ISO WorldSID 50th Task Group

Update To GRSP Informal Group On Side Impact Dummies

September 2012

1D IR-TRACC vs. 2D IR-TRACC in WorldSID

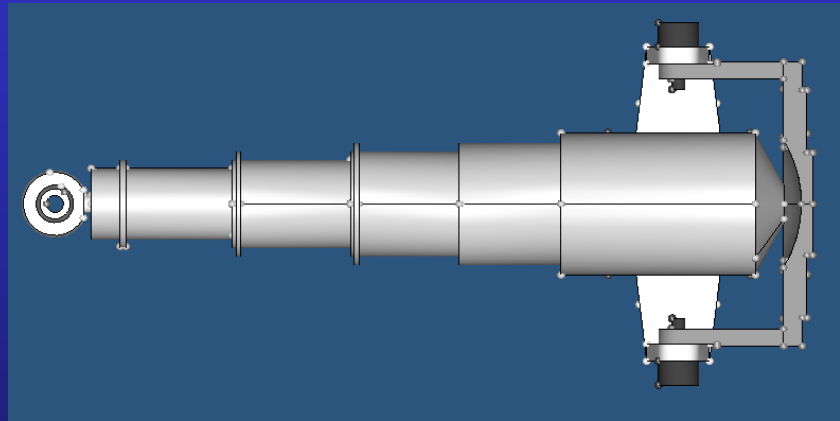
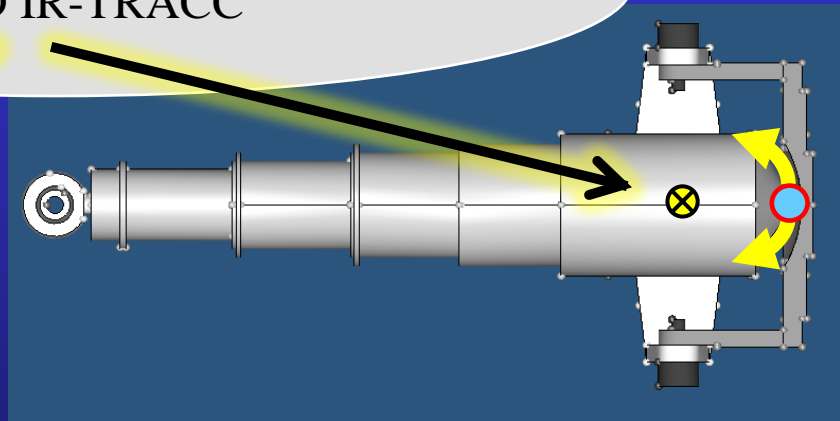
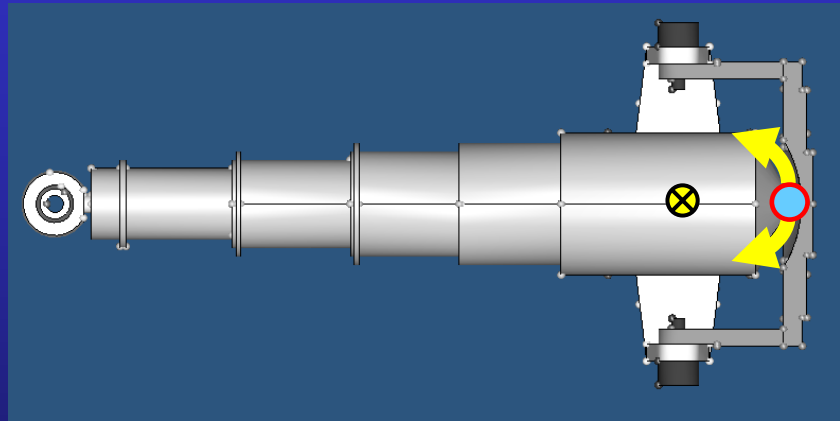
Center of Rotation differs between 1D and 2D IR-TRACC

The WorldSID 50th ISO Task Group recommends the inclusion of 2D IR-TRACC geometry in Build Level F for consistency in center or rotation for all future WorldSIDs.

- The ISO task group has approved a collection of improvements to be included in build level F. These improvements include:
 - Modified suit (enlarged arm openings and reinforced shoulder belt area)
 - Replacement material for Ureol for iliac wings and skull
 - Modified ankles (similar to WS5, allows retention of pre positioned ankle position)
 - Corrected pelvis tilt sensor mount (correcting design error on early dummies)
 - Changes to pubic load cell connectors
 - 2D IR-TRACC (this is a change from previous recommendation)
